## ATTACHMENT (1)

### DETERMINATION OF SIGNIFICANT HAZARDS

**MARKED-UP TECHNICAL SPECIFICATION**

**3/4 1-7**

FIGURE 3.1.1-1

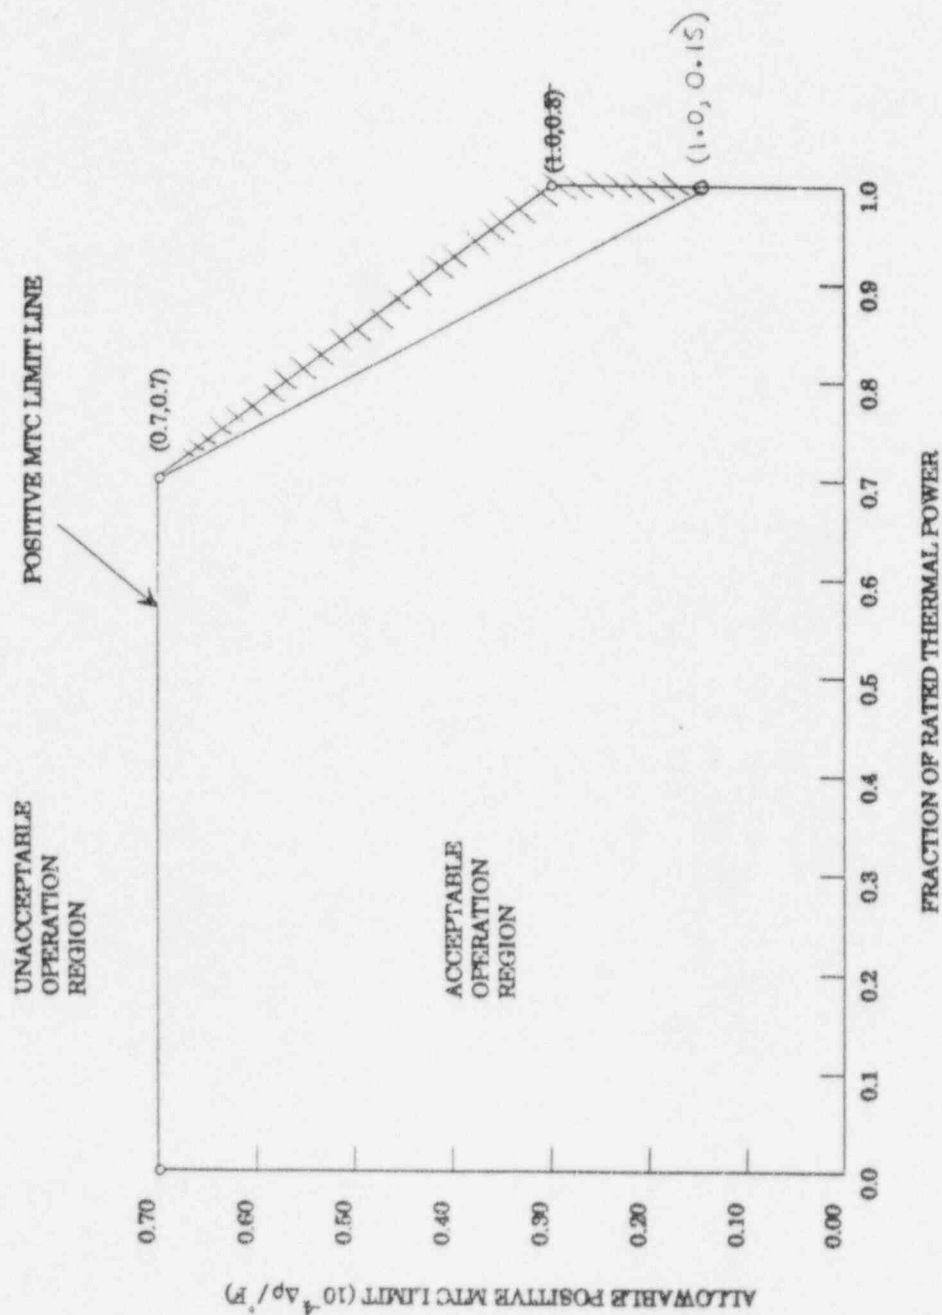
The safety analyses for the current fuel cycles assume 500 tubes per steam generator (SG) are plugged and the maximum beginning-of-cycle moderator temperature coefficient (MTC) is assumed to follow the curve in Technical Specification Figure 3.1.1-1. For the fuel cycle to be installed in Unit 1 in spring 1996, Baltimore Gas and Electric Company (BGE) assumes in the analyses that more SG tubes are plugged than the current limit, and it is necessary to credit a more restrictive (less positive) limit on the maximum positive MTC to mitigate the Reactor Coolant System pressure and temperature increase analyzed for these events. Therefore, we are proposing a change to the allowable positive MTC limits shown on Technical Specification Figure 3.1.1-1. The proposed limit will be more restrictive than the existing limit to match the analytical assumptions. Since the safety analyses supporting an increase in the number of plugged SG tubes are applicable to both Units 1 and 2, BGE is requesting this change for both Units.

The proposed change makes the limit on the maximum positive MTC more restrictive. From an operational standpoint, a more restrictive limit on MTC will help mitigate the effect of plant transients on control of plant parameters (e.g., reactor power, pressurizer pressure, pressurizer level, etc.). Therefore, the probability of a previously analyzed accident will not be significantly increased.

The reason for the proposed change is to mitigate the effect (increased reactor coolant temperatures) of increased SG U-tube plugging on the results of the affected safety analyses. Using the more restrictive limit on the maximum positive MTC, the Loss of Load, Loss of Feedwater Flow, Feed Line Break, and Control Element Assembly Withdrawal events were reanalyzed using previously accepted methodologies. The results of these analyses are within the acceptance limits for these events. Therefore, the consequences of a previously analyzed accident will not be significantly increased.
